ADDENDUM NO. 2

DPW Project #2023256

April 30, 2024

**DPW/UI – Ag Science Building HVAC Phase Two
University of Idaho
Moscow, Idaho**

1 GROUND FLOOR - ENLARGED IDF - ELECTRICAL - DEMO
1/2" = 1'-0"

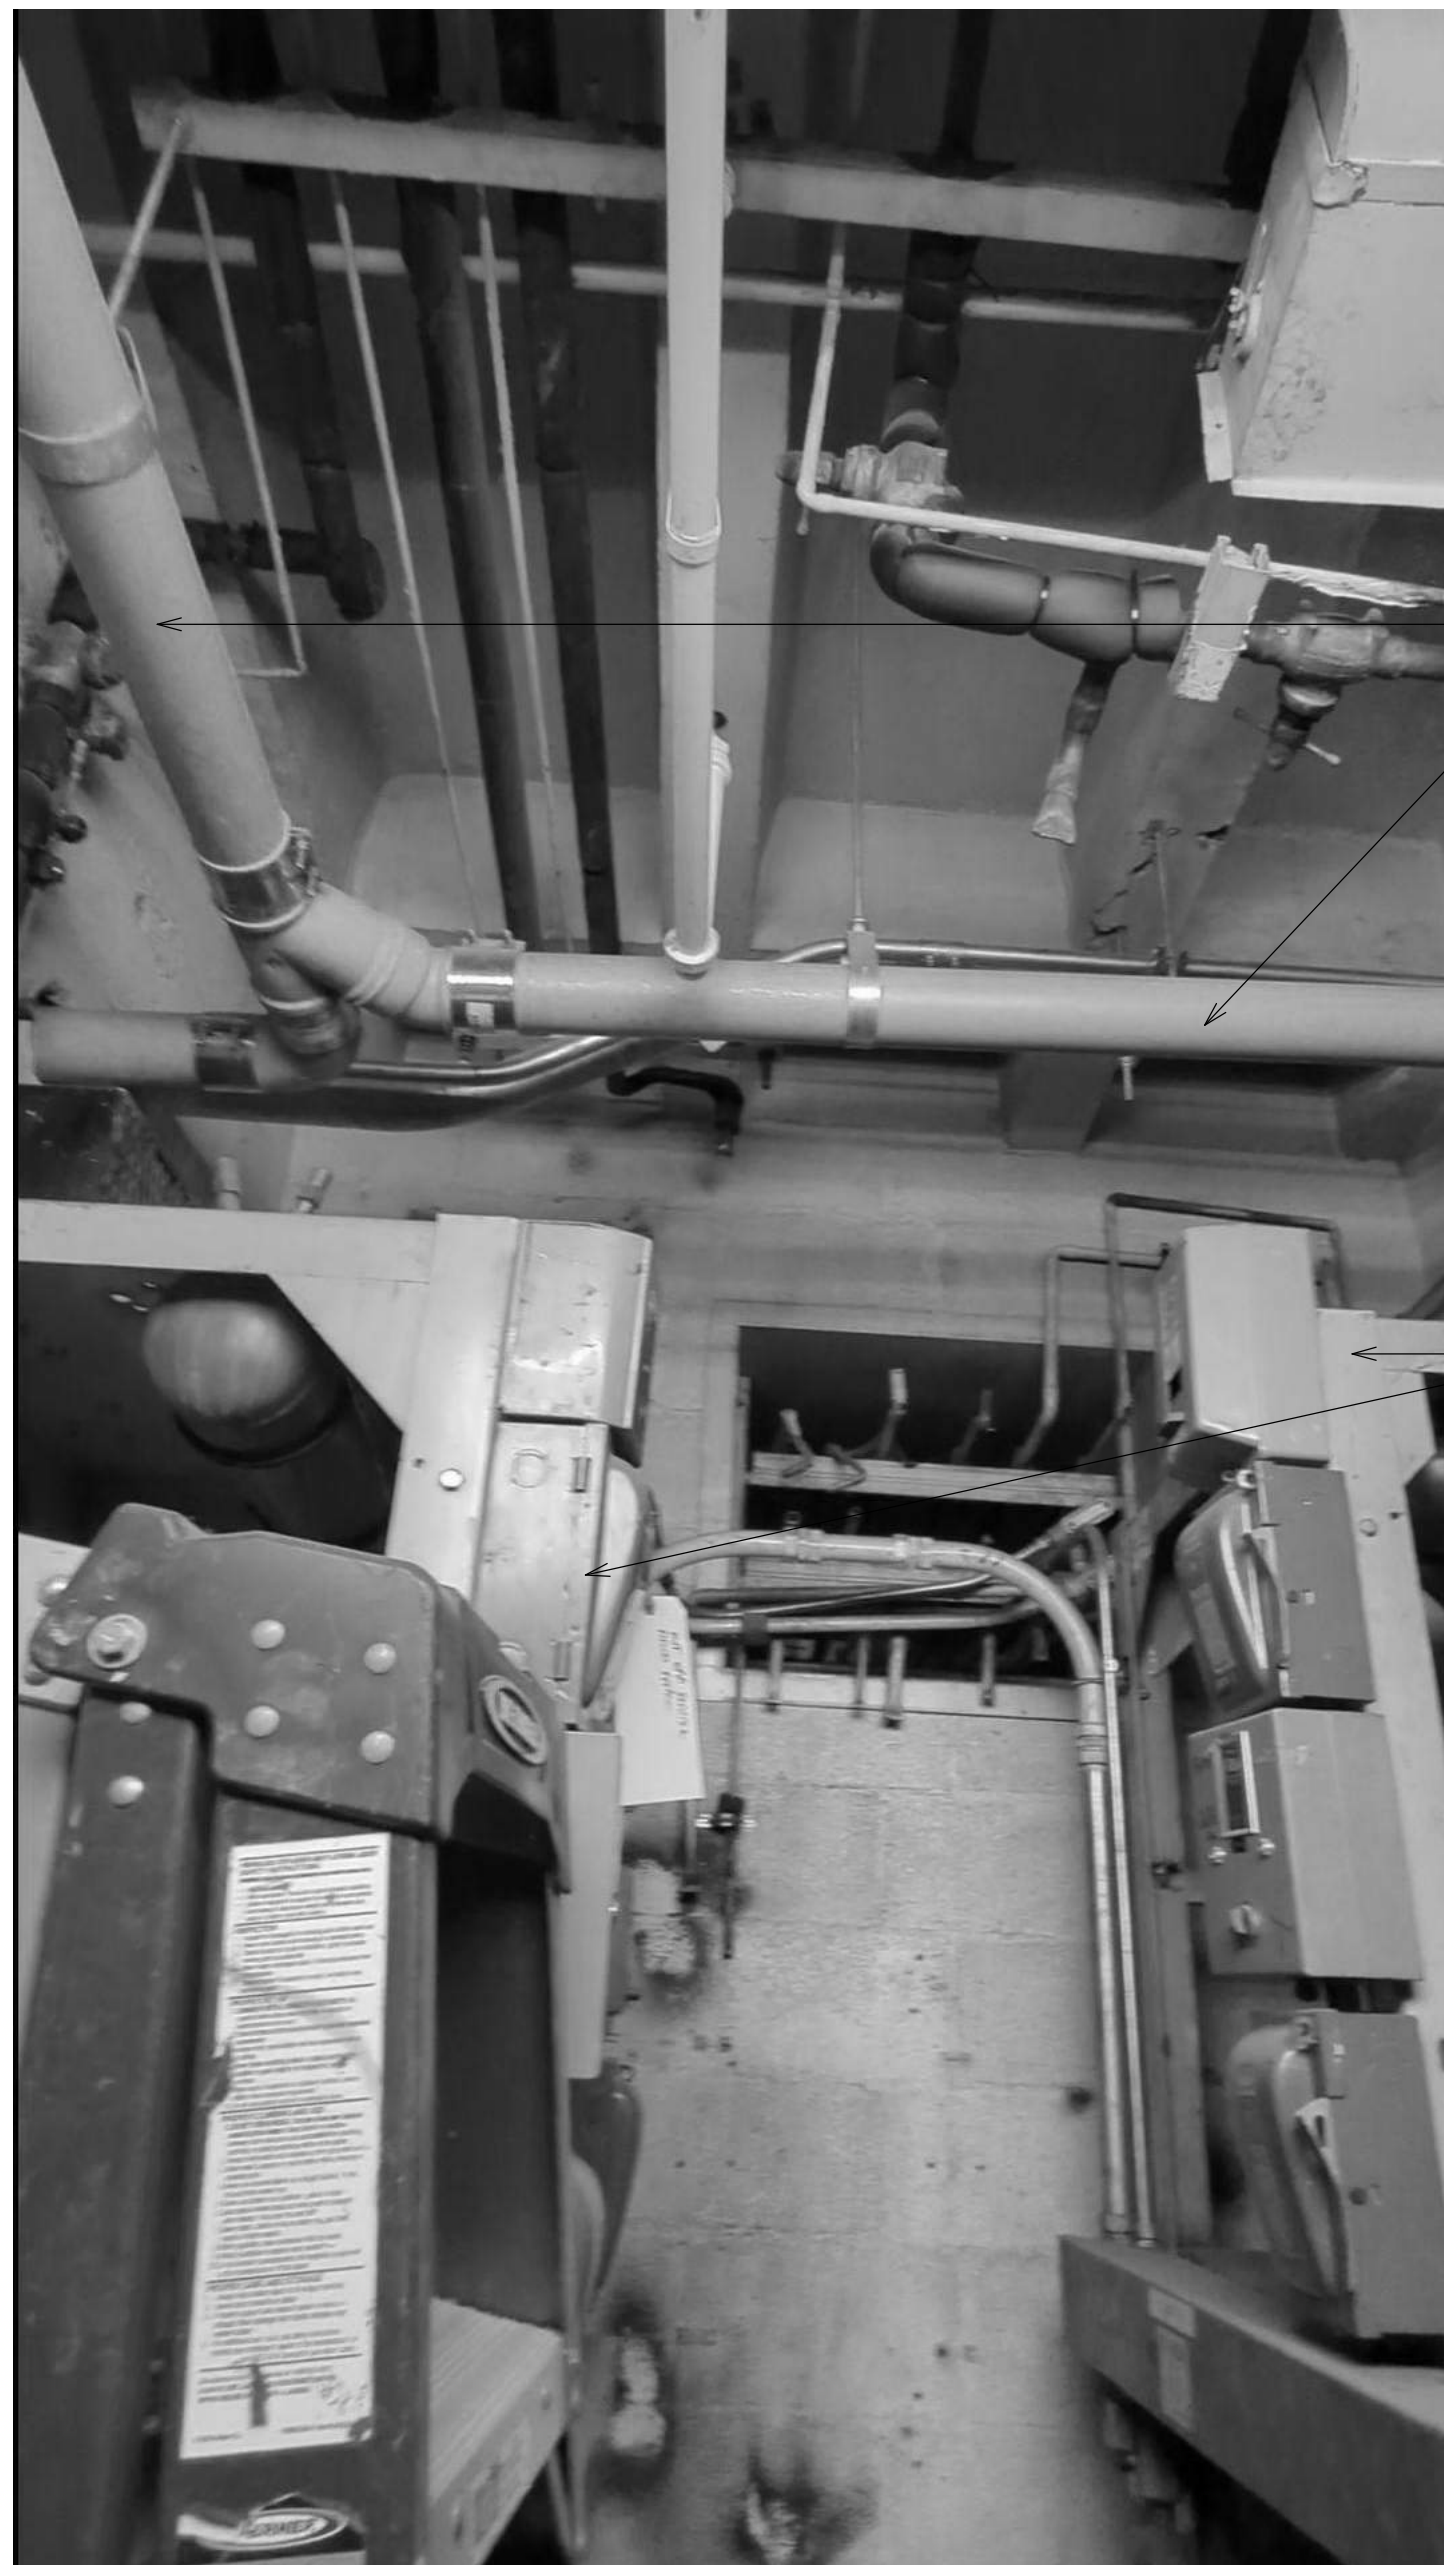
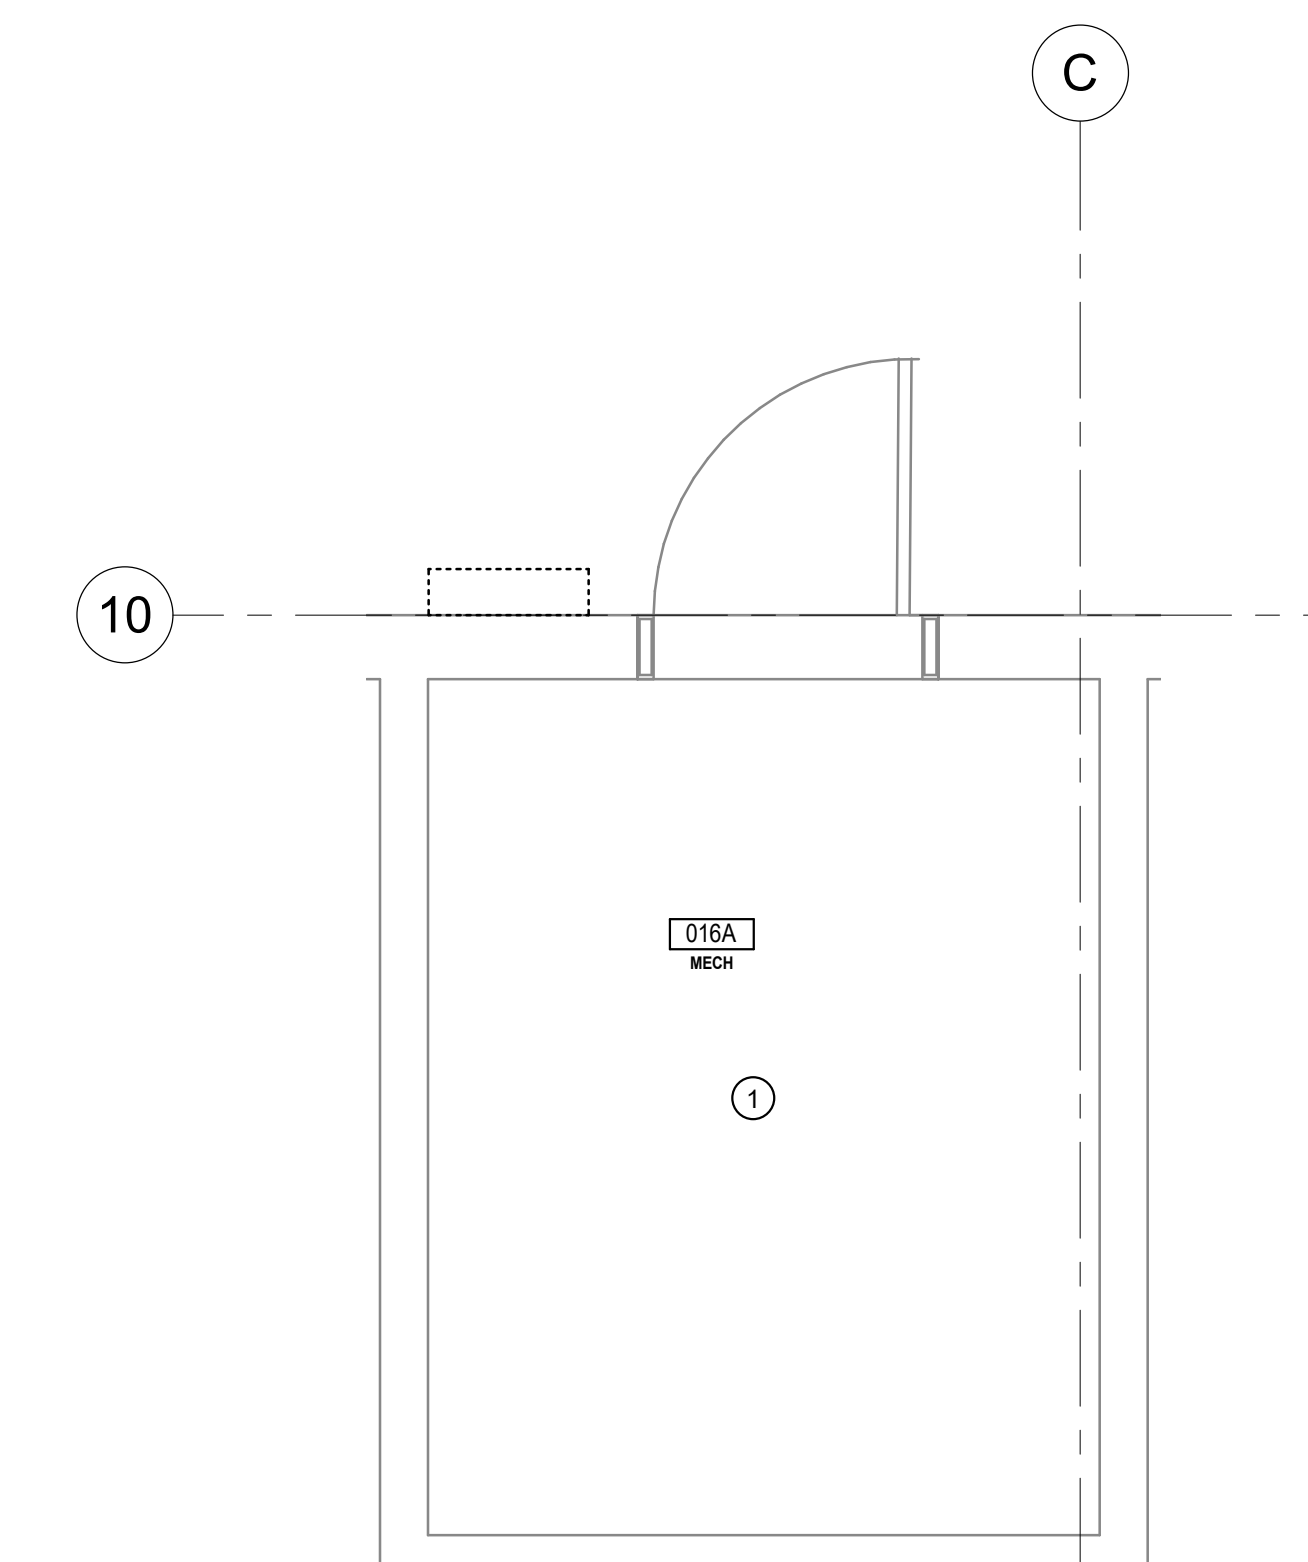
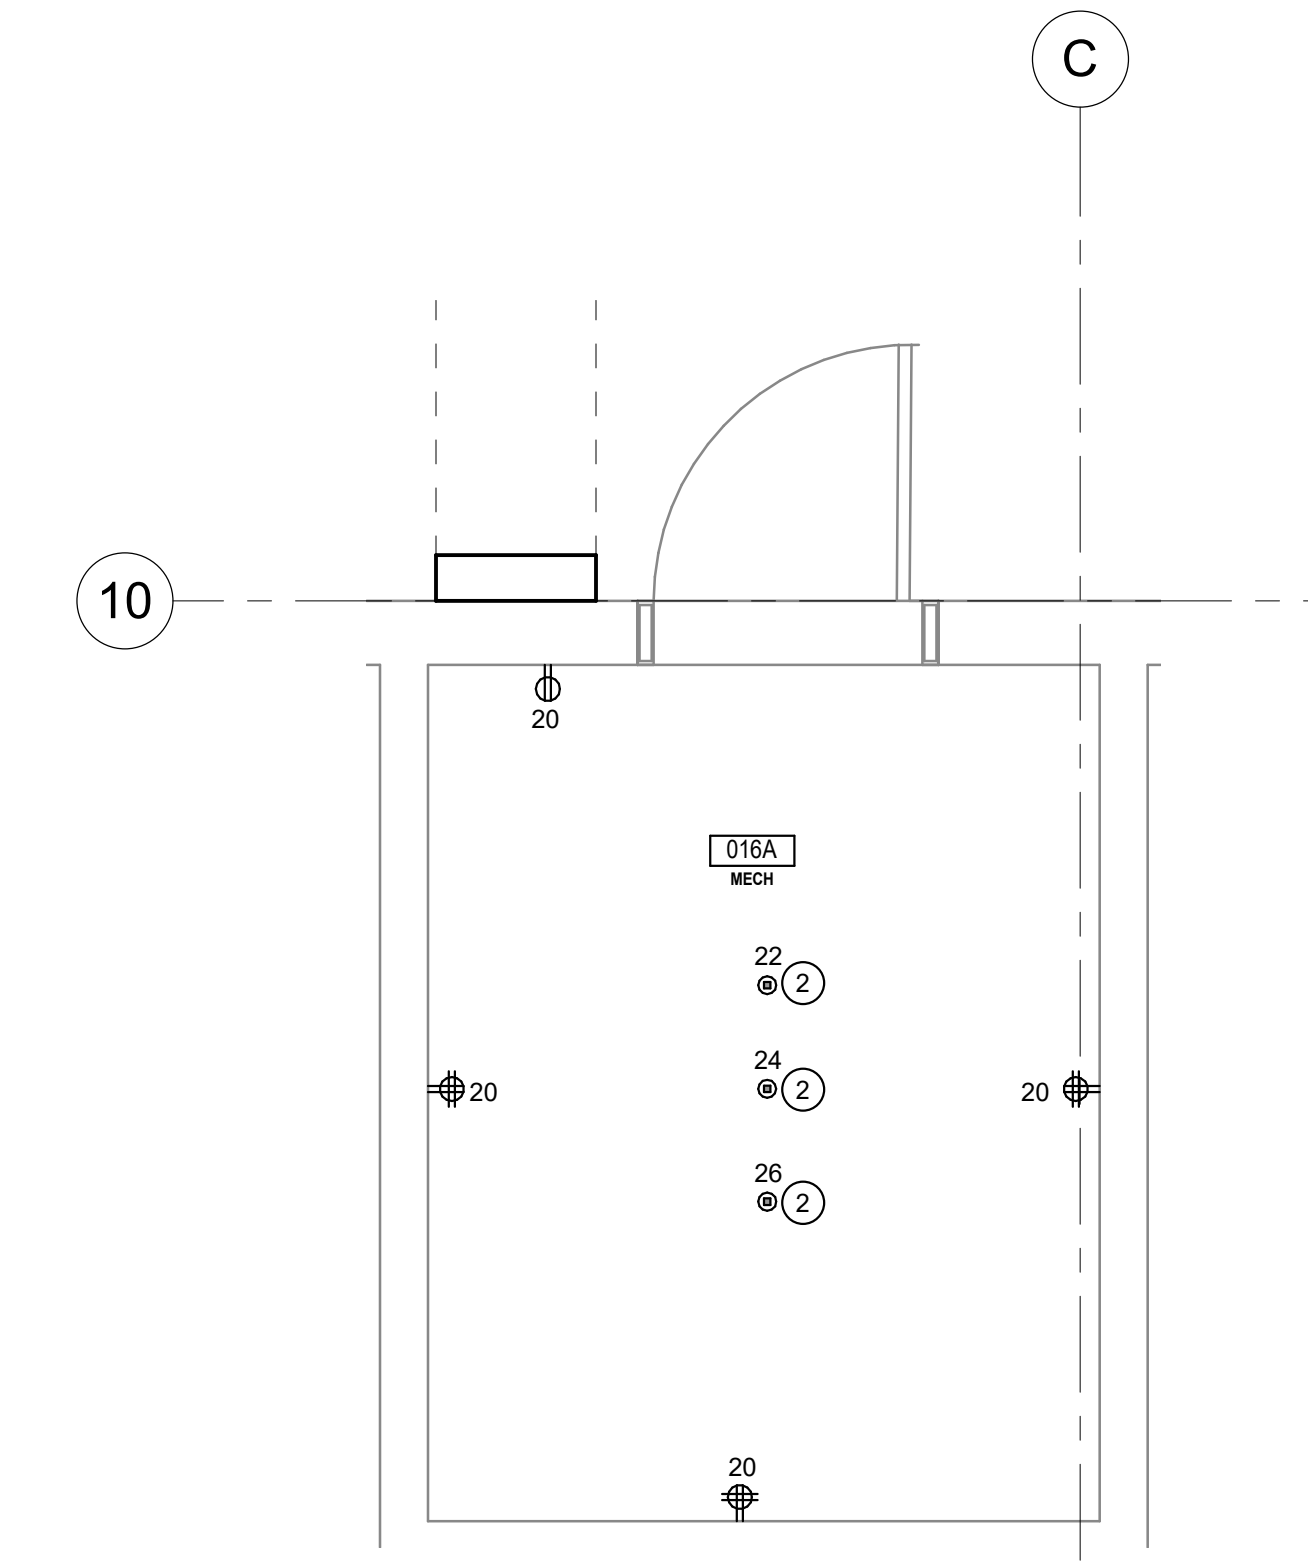
- 2.61 SHEET E4.02 – ENLARGED VIEWS – ELECTRICAL**
ADDITION: See attached added Sheet E4.02 showing requirements for the 016A Telecom Room.
- 2.62 SHEET E6.01– EQUIPMENT SCHEDULES – ELECTRICAL**
ADDITION: Added Type B8E fixture for restroom lighting, Type W-2 fixture for Auditorium lighting, Type W-3 fixture for Auditorium lighting, and Type W-4 fixture for Auditorium lighting. See attached drawing.
